Central Planning Authority

Minutes for a meeting of the Central Planning Authority held on October 12, 2016 at 10:00 a.m. in the Conference Room, 1st Floor, Government Administration Building, Elgin Avenue.

CPA/22/16

FIGURE 1 – PROPOSED SITE PLAN

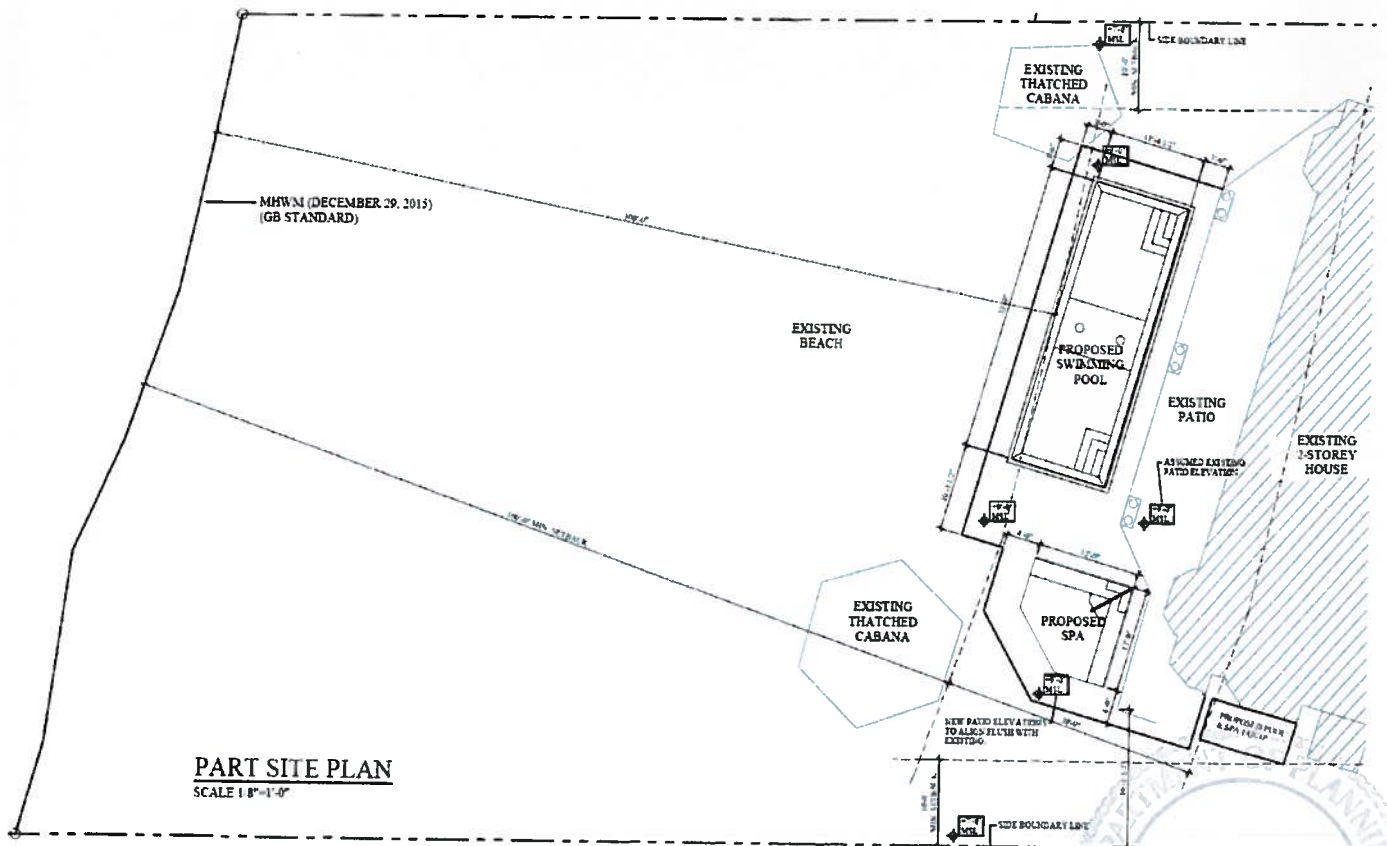
The current setbacks from the SMB high water mark (HWM) is 130 ft to all construction. The previous setback distance was 100 ft and the beach house was sited to meet this requirement which was in force at the time of its construction. The beach width fluctuates with episodic storm events. A review of Lands and Survey's aerial photography since 1956 shows the beach width has varied from a minimum of 81 feet to a maximum of 118 feet.

The most recent HWM survey (29 Dec. 2015) shows the beach width is at 100ft, which is about midpoint of its fluctuation range. The proposed pool deck would be 95 feet 5 inches from the HWM at the current beach width.

The proposed pool and deck is located centrally on the Seascape site (**Figure 1**). Storm waves either impact the pool wall or continue to run between the buildings as is the current condition. The pool and deck will not make storm wave or flooding conditions worse for the neighbouring properties. As evidenced during Hurricane Ivan, the most damaging flooding came from North Sound overflowing onto the Seven Mile Peninsula, the neighbouring properties are potentially at equal risk of flooding from their landward side depending on the storm track.

FIGURE 2 –PROPOSED POOL SECTION

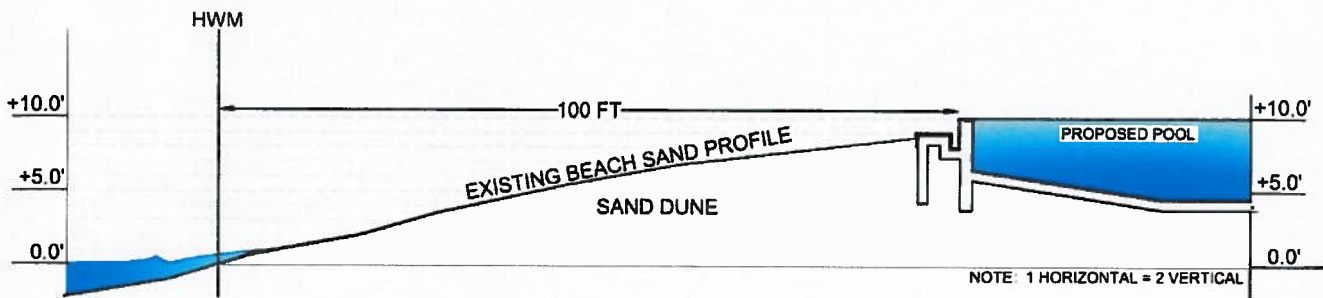
The construction of the pool and deck will enhance the building's resistance to damage from storm wave impacts (Figure 2).

FIGURE 10 – LOCATIONS OF EXAMPLE STRUCTURES BUILT ALONG SMB

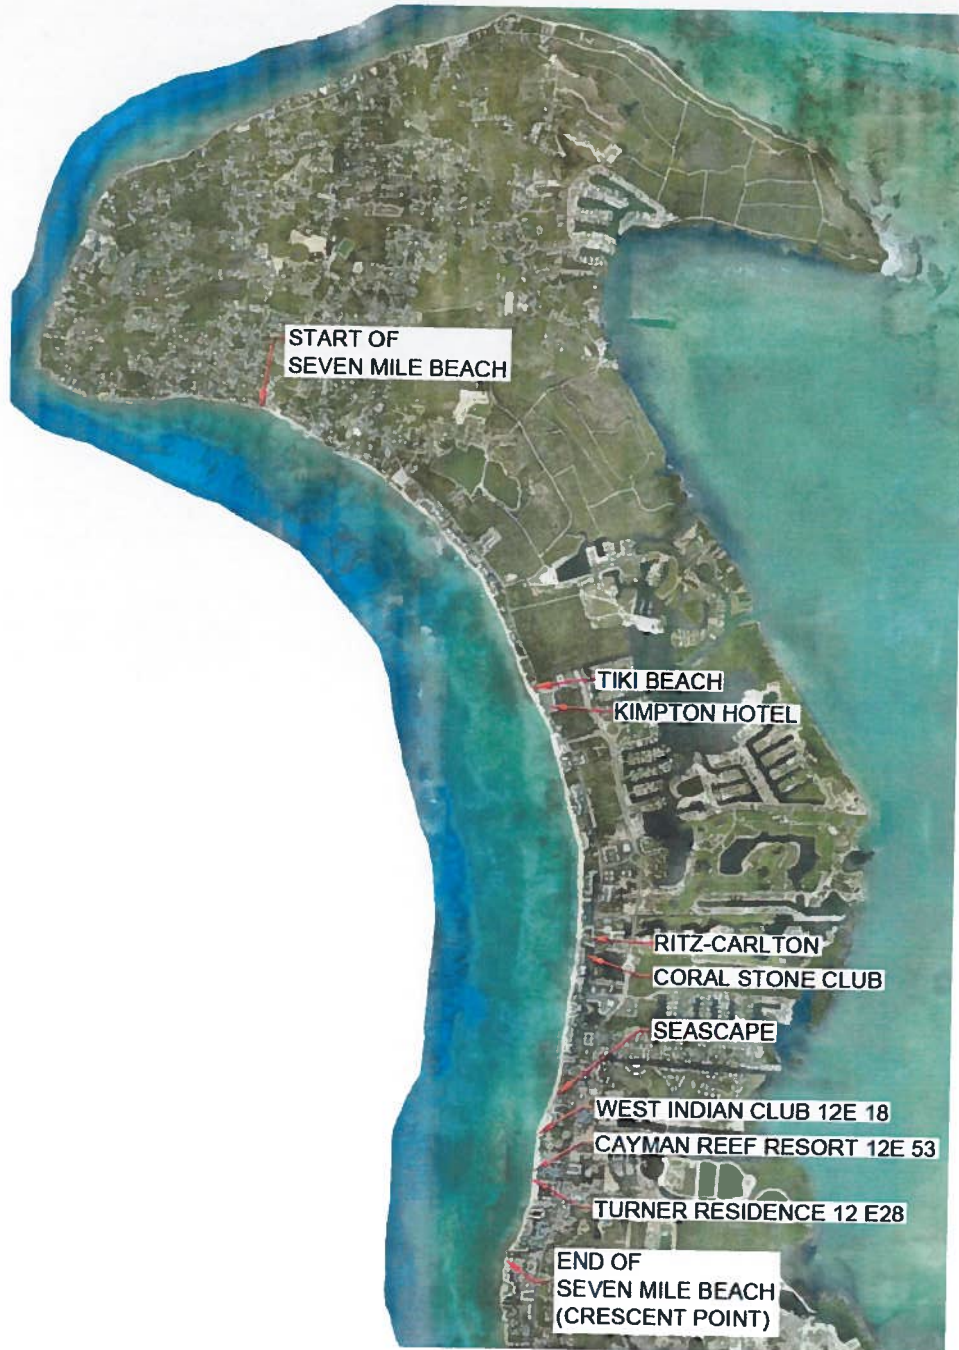
The Department of Environment's memo states *'The siting of hard structures such as a pool and pool deck within the required setback, not only encroaches on the existing natural beach area and profile, but also has the potential to interrupt the natural fluctuation of beach width and height. As a general principle, the greater the distance waves can travel up a beach profile before encountering a physical barrier, the more energy is dissipated, therefore reducing the erosion of sand by wave energy away from the beach. If waves directly interact with a structure, such as the edge of a pool or pool deck edge, they are reflected seaward thus exacerbating sand erosion from the beach. This has been seen in a number of instances locally including along the northern section of Seven Mile Beach, part of which is now permanently affected and impassible to pedestrians on the beach front'*.

We do not agree with DOE's statement. The physical evidence from SMB shows these walls do not inhibit the beach's natural recovery post storm. Many seawalls have been constructed on SMB over the years to protect beach front properties from storm damage and beach erosion impacts. The following is a brief review of four (4) such walls which APEC has observed since 2000. The location of these walls is shown on **Figure 10**.
